Report to the Future Melbourne Committee

Planning Permit Application: TP-2023-168
602-606 Little Bourke Street, Melbourne

1 August 2023

Figure 6 – Existing / demolition elevation (left) and proposed elevation (right) to Little Bourke Street.

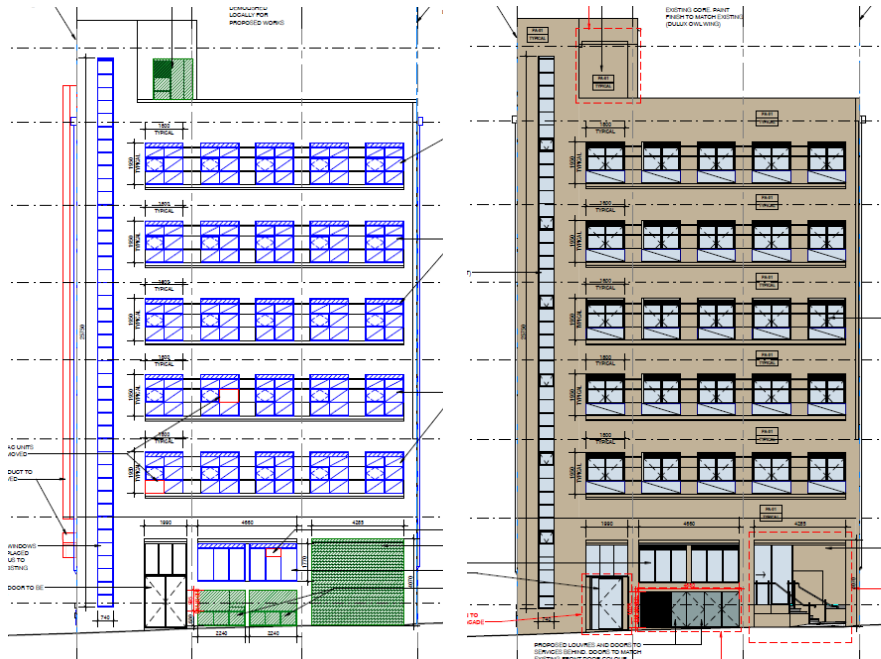
- Demolish section of south-facing wall above existing windows to increase height of openings on Little Bourke Street elevation.
- Remove existing air-conditioning units from Little Bourke Street elevation and ducts along Rose Lane elevation.
- Demolish section of east-facing wall to principal portion of building at ground level to create new opening on Pender Alley elevation.
- Remove existing windows and demolish section of east-facing wall to rear portion of building at ground level to create new opening on Pender Alley elevation.
- Demolish section of west-facing wall on Level 2 of the building to create new window opening on Rose Lane elevation.
- Demolish sections of wall, shaft and roof of the existing lift room on the rooftop.
- Remove windows and demolish section of south-facing wall to create enlarged opening on the rooftop.
- Remove existing roller doors along each elevation.

- External alterations to replace all windows (inclusive of frames and glazing) with new windows consisting of double glazed units.
 - A majority of the windows (levels 1 to 5) will be replaced with operable units with a glass balustrade and inward opening casements.

Figure 7 – Excerpt from Application TP-2023-168 Urban Design Advice

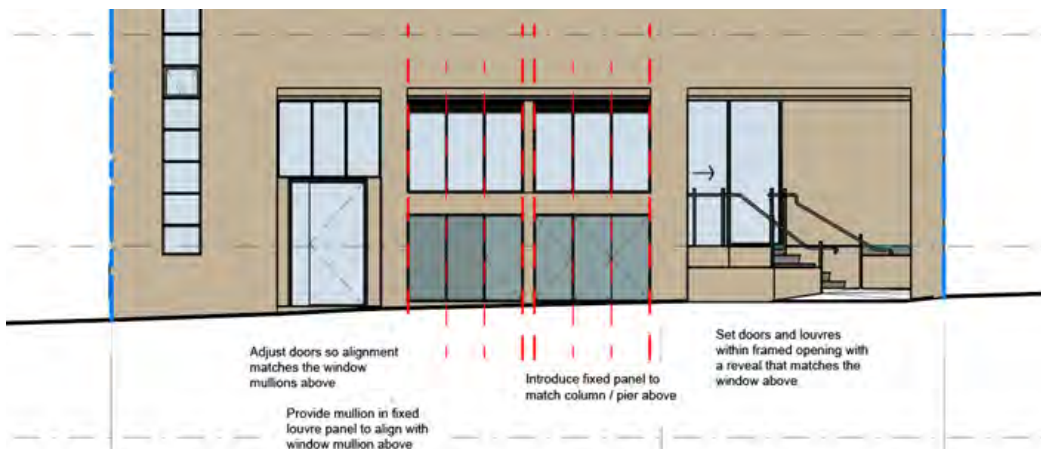
Council's Urban Design team provided the following diagram to further clarify their recommendations regarding the service cabinets:

The recommendation for a revised design of the service cabinet will provide a visual improvement to the presentation of the building, as viewed from Little Bourke Street at street level.

It is recommended that a condition be included on any permit being granted to require the submission of amended plans with revisions to the arrangement of the service cabinets as shown above. Subject to this change, it is considered that the proposal will suitably align with the design objectives of the DDO1.
